Re: Marlisue Queen Unit

Waterflood Case No. 8002/Order No. R-7422

Injection Pressure Increase

## B & D WELL TESTERS Step Rate Test

McCLELLAN OIL CORP.
MARLISUE TRACT 2 #6
3-26-85

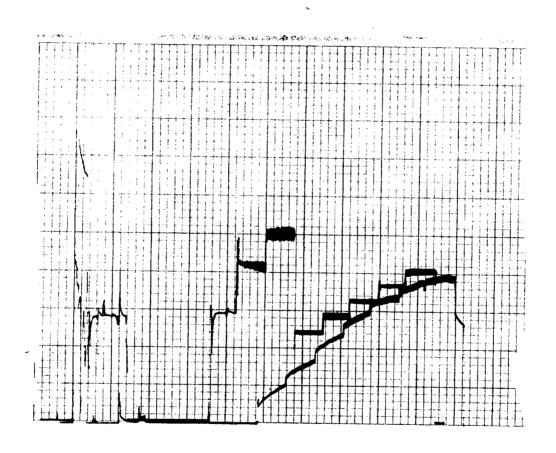
Stephens Engineering has reviewed the step rate test performed by B & D Well Testers on March 26, 1985 on Marlisue well No. 2-6. It is the opinion of Stephens Engineering that the fracture pressure established by B & D Well Testers of 1,060 psi wellhead pressure is probably low due to the fact that the step rate test began with the injection well on a vacuum. It should be noted that fracture gradients are directly related to pore pressure, which in the case of this well was at a minimum due to the fact that fillup of the near wellbore storage area had not been established prior to the step rate test. Without this fillup the near wellbore area will have a minimum pore pressure and therefore an abnormally low fracture gradient until such time that the injection well reaches fillup. This phenomenon is easily illustrated when step rate tests are run concurrently on producing and injection wells in the same reservoir. The producing well, due to the decreased pore pressure caused by production, will show an extremely low fracture gradient whereas the injection well will show a much higher fracture gradient due to increased pore pressure caused by injection. This phenomenon can further be proved by the fact that fracture gradients increase as waterfloods become more mature. The reason is the same. Increased injection causes an increase in fillup and therefore an increase in pore pressure which is directly related to an increase in the fracture gradient.

Enclosed is the data from the step-rate test that you requested. B & D Well Testers plotted the frac pressure at 1060 psi WHP, whereas, I plotted the frac pressure at 1280 psi WHP. It is evident that the requested 1000 psi wellhead injection pressure will not result in fracturing of the Queen Formation in this unit.

Therefore, we request that the referenced Order No. R-7422 limiting injection pressure to .2 psi per foot be revised to read that the maximum wellhead pressure be 1000 psiq.

the steprate test on the Malline Tr. 2#6 3-26-85

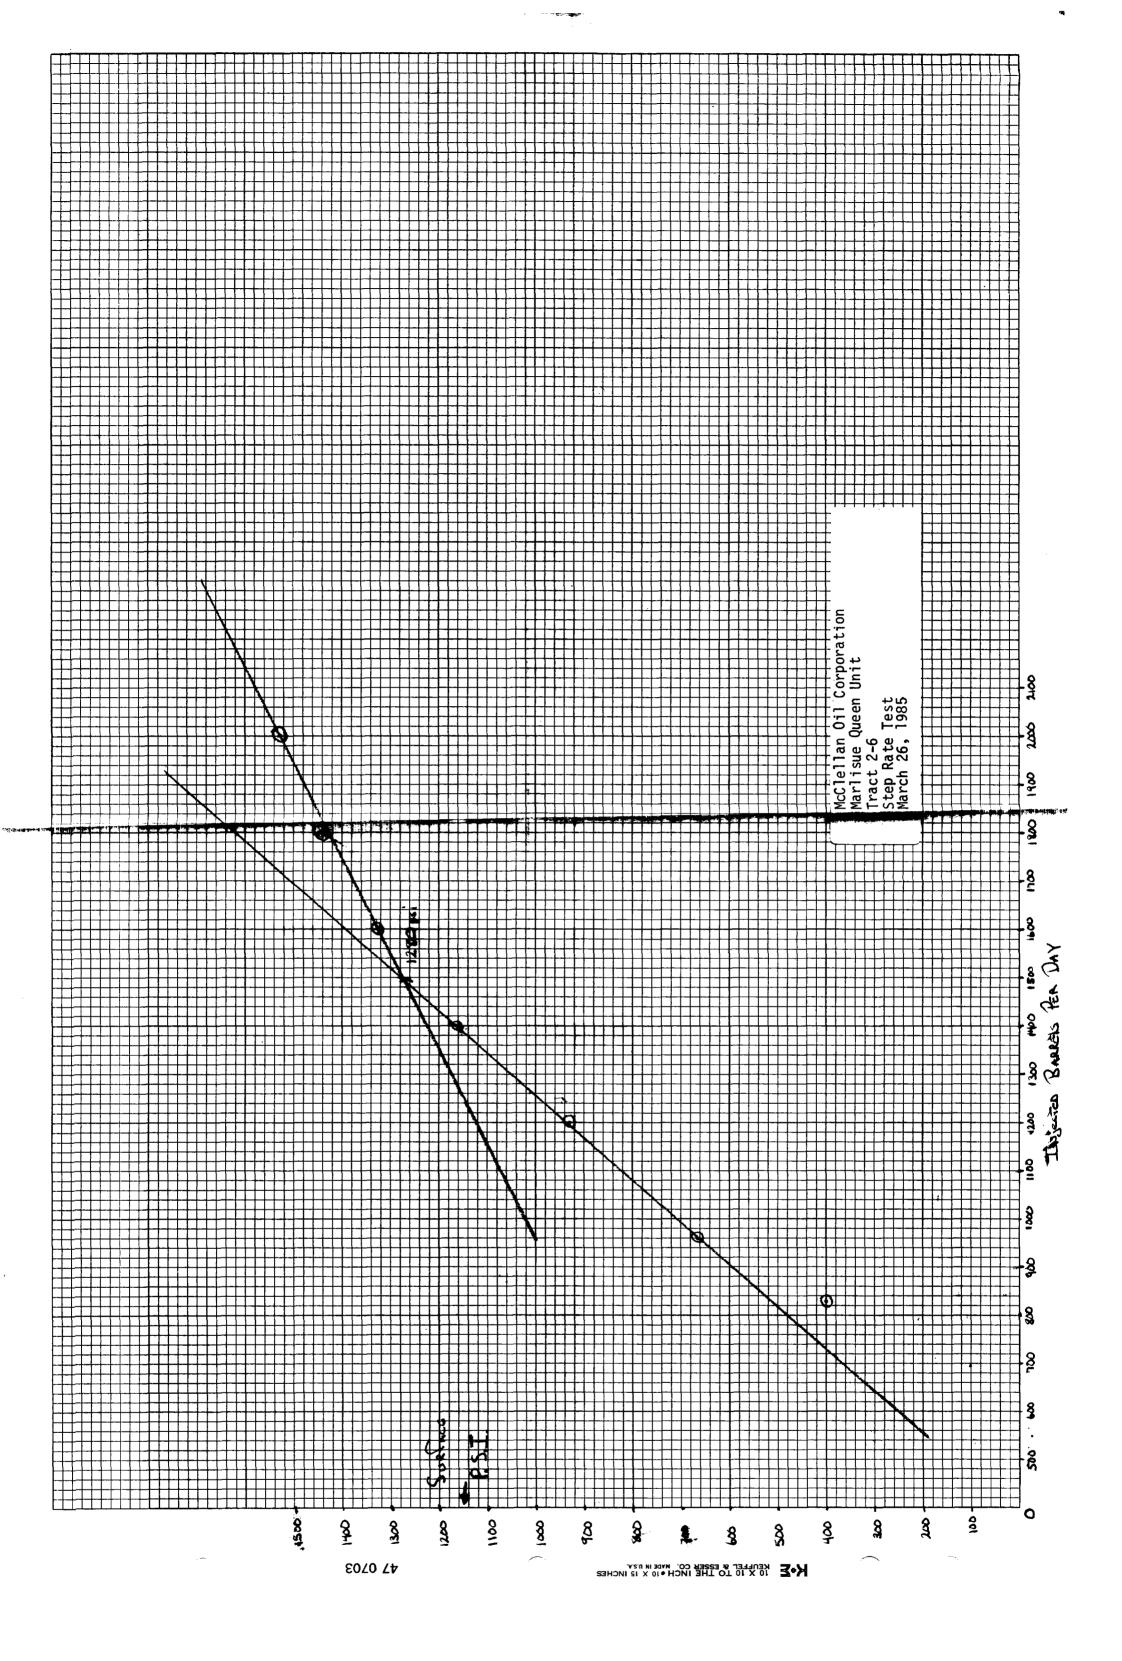
As per McClellans request to inject @ 1000 psi!

indicates a break @ 1080 as plotled. A low pressure

value of 935 is indicated as possible charring of perforations?

WI the low values implied and the upper pressure

considered a break could have occurred @

1020 psi.
